FIVE-STOREY VACATION VILLA — SHAMANDEEL, QUESNA, MENOUFIA, EGYPT

CENTRAL KITCHEN & LAUNDRY — ENLARGED PLAN

DRAWING No	REVISION	SCALE	DATE
A-302	**P4**	**1:25 @ A1**	**2026-10-07**

CENTRAL KITCHEN & LAUNDRY — ENLARGED PLAN

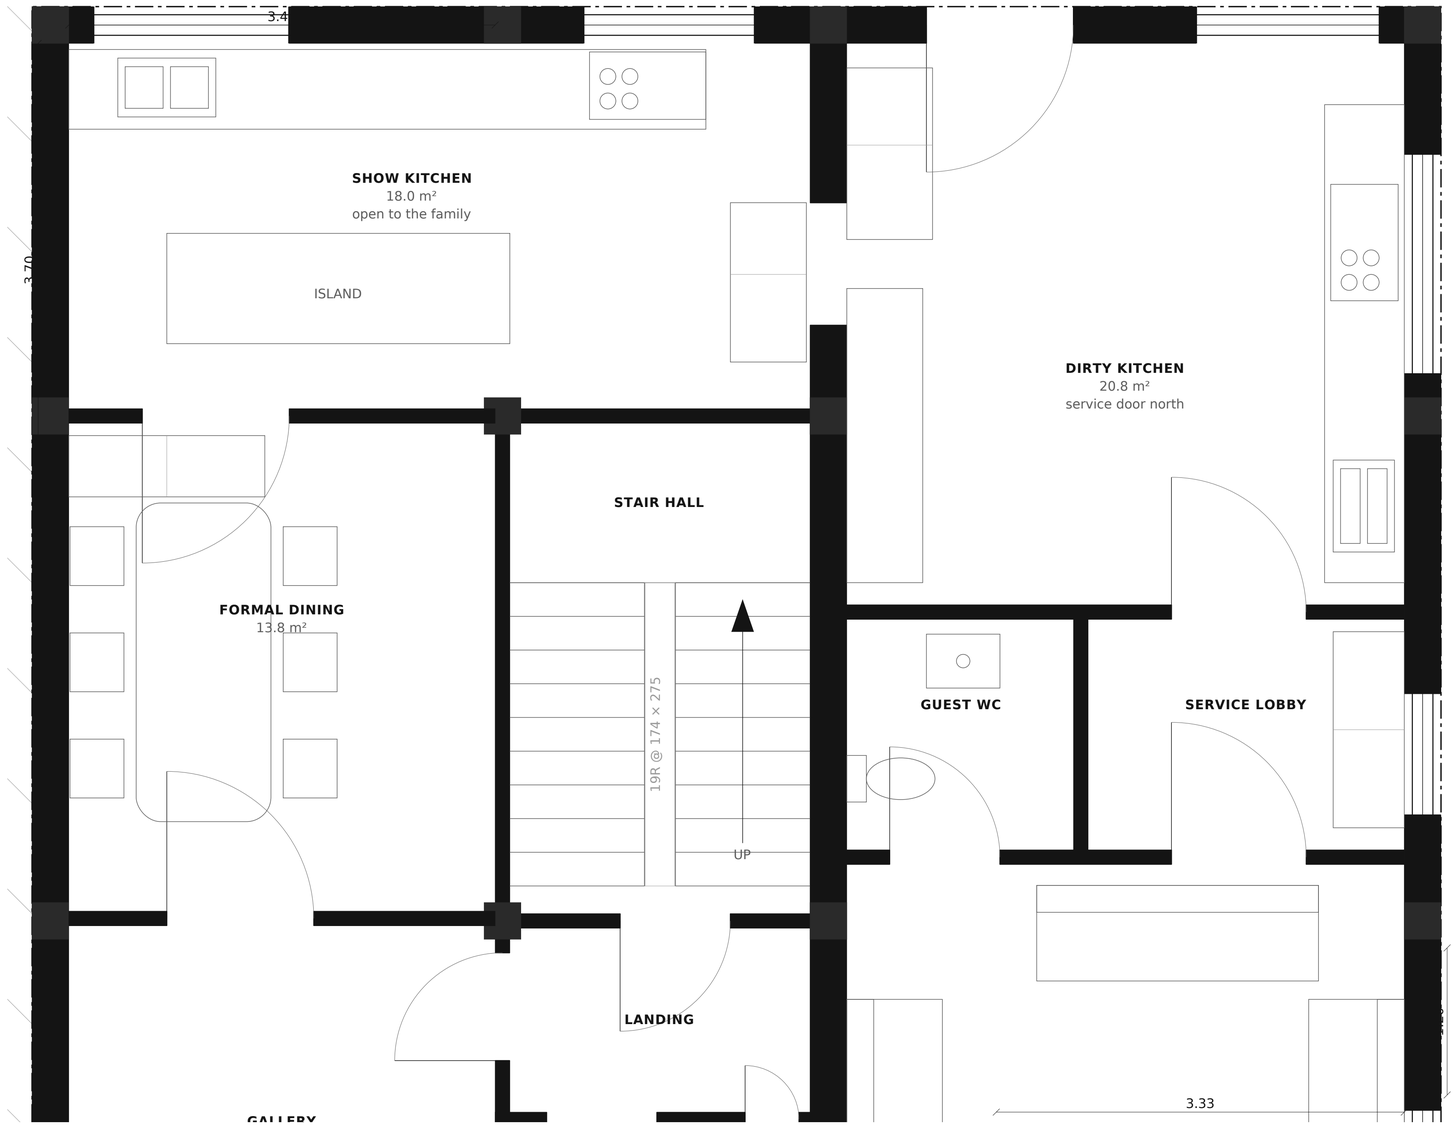
1. Enlarged from A-100. The kitchen is reduced 30 % on the client's instruction; the area released carries a staff WC, an internal bin store and a servery on the route in, so bins no longer stand out on the patio.

3. Laundry takes one washer-dryer, a utility sink and a folding counter, as instructed. Linen and housekeeping stores are next to it off the same hall.

SERVICE KITCHEN	12.9 m²
SERVERY	3.0 m²
WASH-UP	3.2 m²
STAFF WC	2.0 m²
BIN STORE	1.9 m²
CENTRAL LAUNDRY	4.0 m²
GUEST BATH	5.9 m²
LINEN & STORE	3.3 m²
TOTAL	**36.2 m²**
KITCHEN, PREVIOUS ISSUE	18.4 m²
KITCHEN, THIS ISSUE	12.9 m² (−30 %)
LAUNDRY, PREVIOUS ISSUE	10.4 m²
LAUNDRY, THIS ISSUE	4.0 m²
